Intel Atom[®] Processor E3800

Specification Update

(Formerly Bay Trail -I SoC)

August 2017

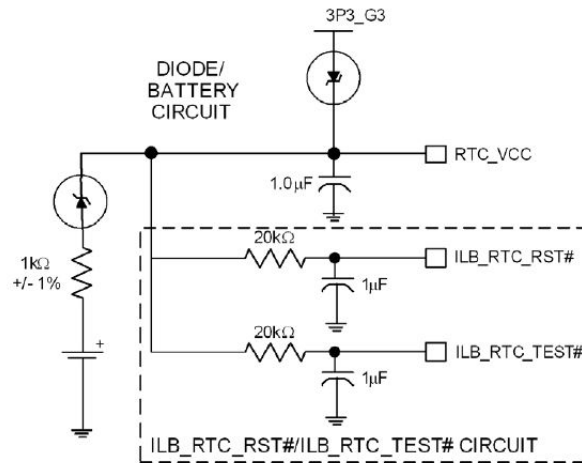
The RC delay between RTC_VCC to ILB_RTC_TEST and ILB_RTC_RST, Figure 21-4 in Section 21.2.3 of the PDG (Doc ID #512379) is obtained by using the formula $t = -\ln((RTC_VCC - V_{ih\ min})/RTC_VCC) * R * C$ and the added circuit is as follows:
